Subject: Dresden Station Units 2 and 3
Response to Questions on
Liquid Hydrogen Storage
NRC Docket Nos: 50-237 and 50-249

DRESDEN 2/3 NRC QUESTIONS ON HYDROGEN STORAGE TANK

Figure 1

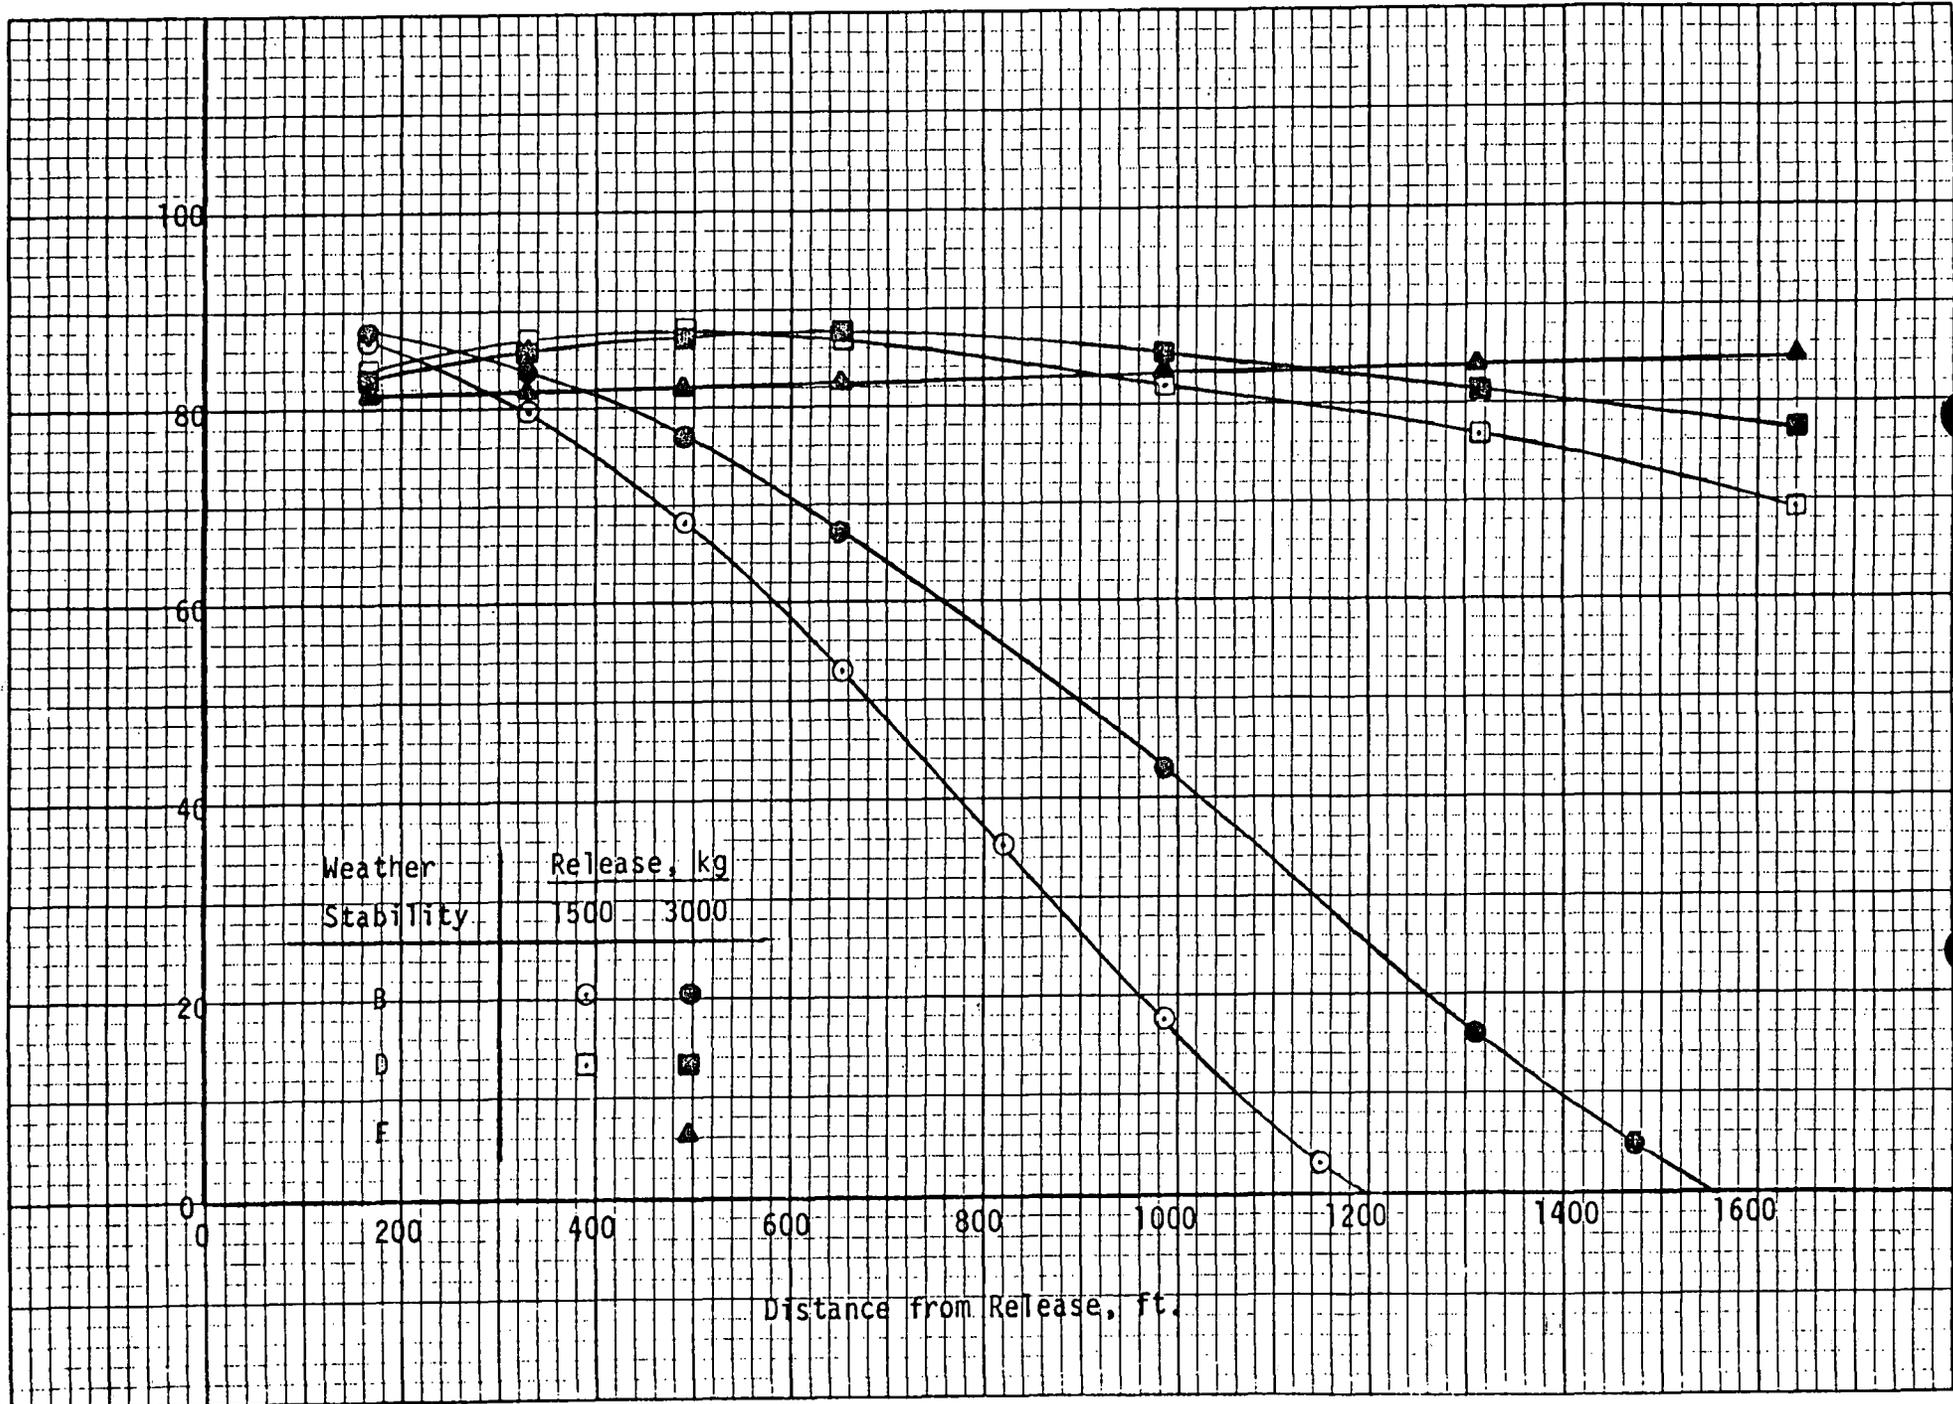
311.6 (Section 2.2.3) Provide a drawing of the flammable portion of the postulated hydrogen cloud path on an up-to-date plot plan of the Dresden Nuclear Station (assuming PASQUILL "F" and wind velocity (u) = 1 meter/second). Indicate on a scaled "Side View" of the Dresden complex the path of the flammable portion of the hydrogen plume considering the bouyancy of the hydrogen gas. Indicate the distance from the centroid of the hydrogen plume explosion to the nearest vertical and horizontal surfaces of safety related structures.

The Pasquill F stability class is not the worst case for the postulated release. The D stability class results in a rate of dilution that maximizes the quantity of release in the flammable range for distances within 640 ft. of safety related structures (see attached Figure 1). The analysis is considered very conservative because it assumes that for all cases 88% of the total release will be in the flammable range. If 100% of the total mass released contributed to a blast wave, the distances would only increase by 4.4% (using W^{1/3} scaling).

The saturated vapor from the flashing and evaporating liquid hydrogen release would have approximately neutral buoyancy (unlike ambient temperature hydrogen gas which has a specific gravity of 2/29). Because of this fact, the cloud was modeled using standard Gaussian with no credit taken for any vertical displacement. Since this assumption results in the shortest distances from the epicenter to safety-related structures, the results are considered to be conservative.
